MEMORANDUM

SUBJECT: Site Plan Approval – 400 Washington Street

DATE: August 28, 2025

Request: Site Plan Approval to construct an approximately 8,600 SF office building and associated site improvements, and a Special Use Permit to establish an accessory Drive-Through use at 400 Washington Street, Parcel Number 8-47-106.200.

LANDSCAPING PLAN

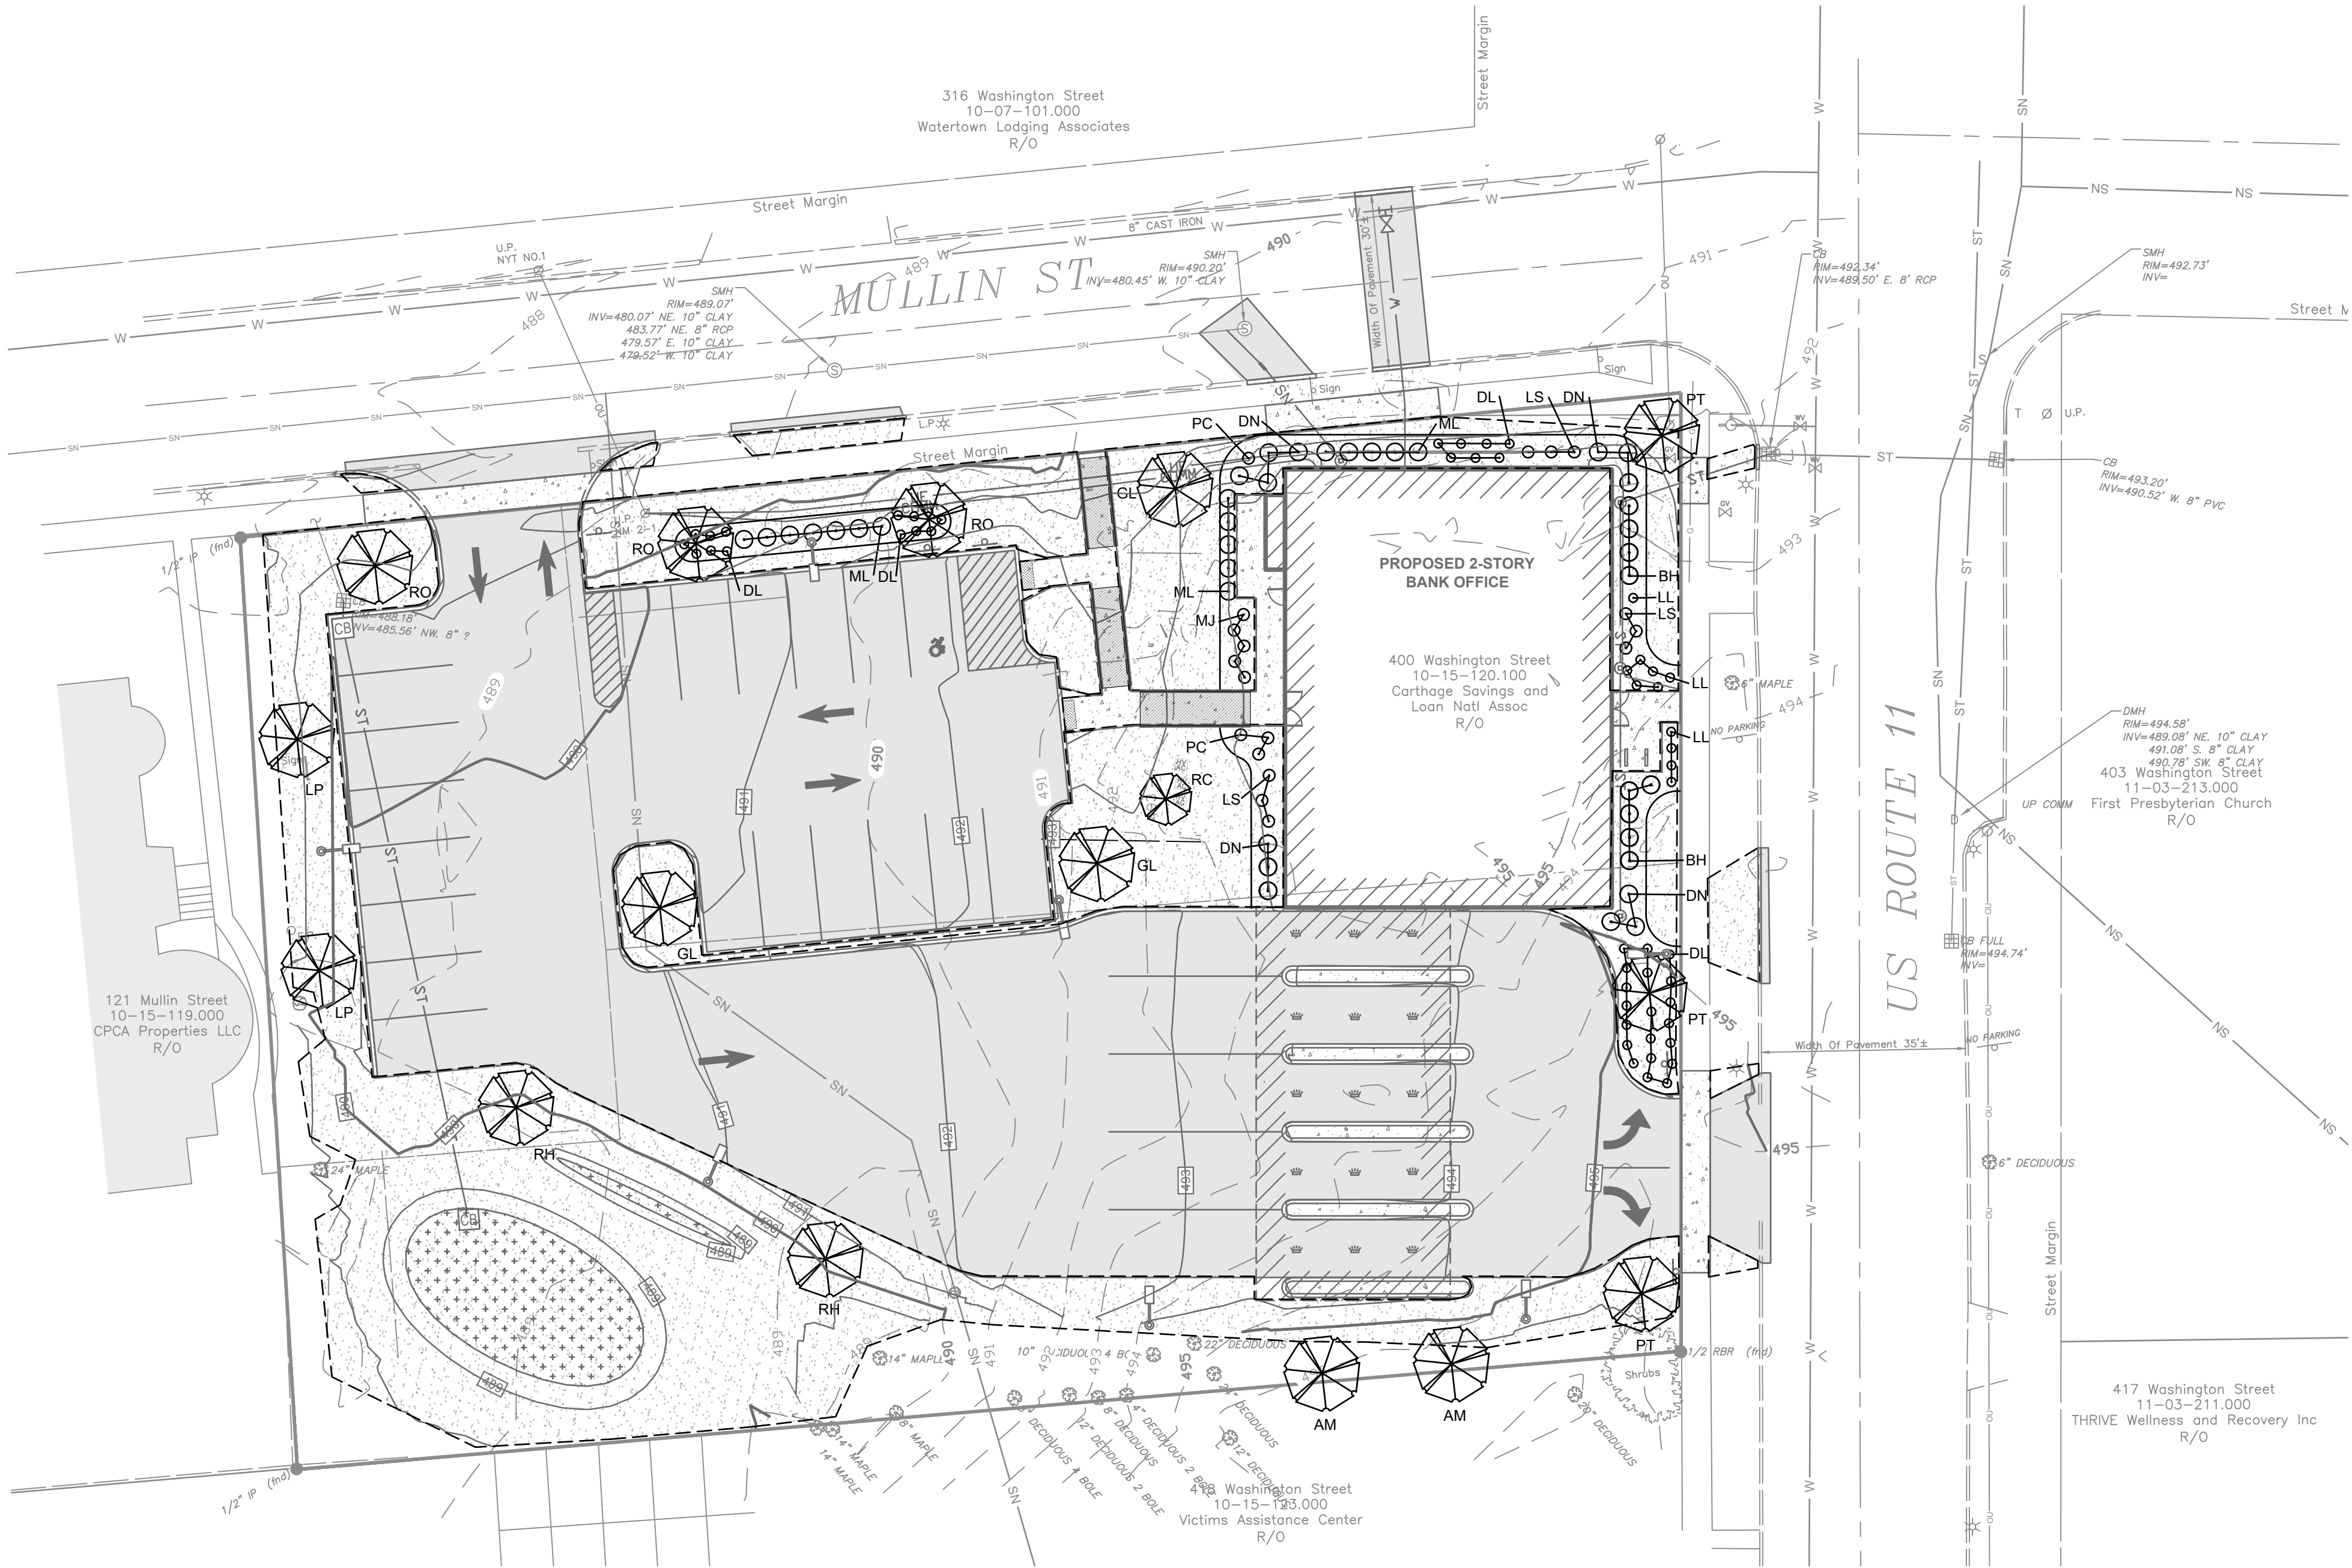
Landscaping: The applicant submitted a Landscape Plan (Sheet C-107) that depicts a landscaped buffer of varying width around the full perimeter of the site, exclusive of driveways. Section 310-83 of the Zoning Ordinance, that requires a 15’ landscaped strip along all Rights-of-Way (ROW), exclusive of the ROW itself. This section of code also requires that where parking lots and/or driveways abut the landscaped strip along the street ROW, shrubs shall be used for screening in addition to shade trees.

Around the perimeter of the property, the width of landscaped areas, spacing of shade and under-wire trees and use of shrubs meets the requirements of the code mentioned above. The plan also meets the required level of species diversity. The number of shade trees relative to the number of parking spaces meets the internal parking lot landscaping requirements of one tree for each fifteen parking spaces or fraction thereof. In instances where the maximum setback is less than the perimeter landscaping requirement, the setback takes precedence, and the narrower landscaped strip is acceptable.

1	BREAK-AWAY SIGN POST DETAIL	
C502	NOT TO SCALE	D135-01

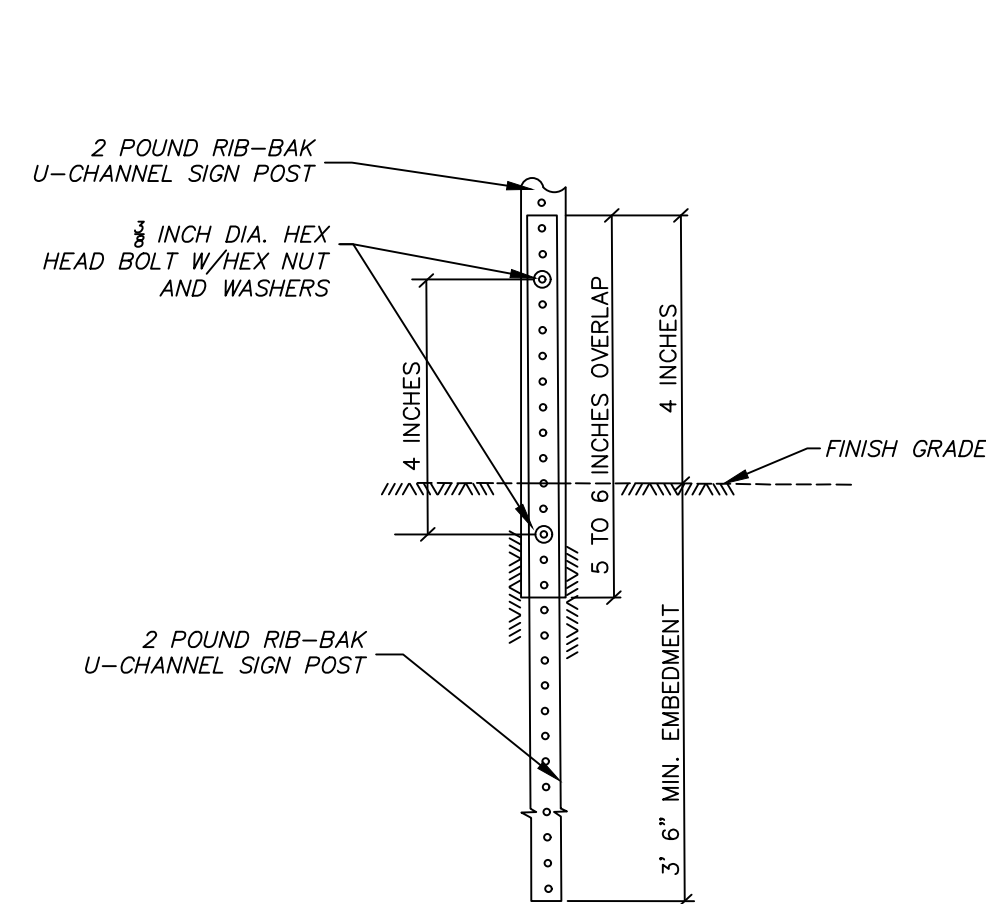
Finally, while the applicant proposes a stop sign on a breakaway signpost where the drive-through exit crosses the Washington Street sidewalk, the applicant should also paint a stop bar on the internal side of the exit aisle to emphasize to exiting motorists that pedestrians have the right of way. This should be added to the plans regardless of the results of the traffic study.

5. The applicant shall add a painted and labeled stop bar to the plans in addition to the breakaway stop sign at the point where the drive-through exit lane crosses the Washington Street sidewalk.
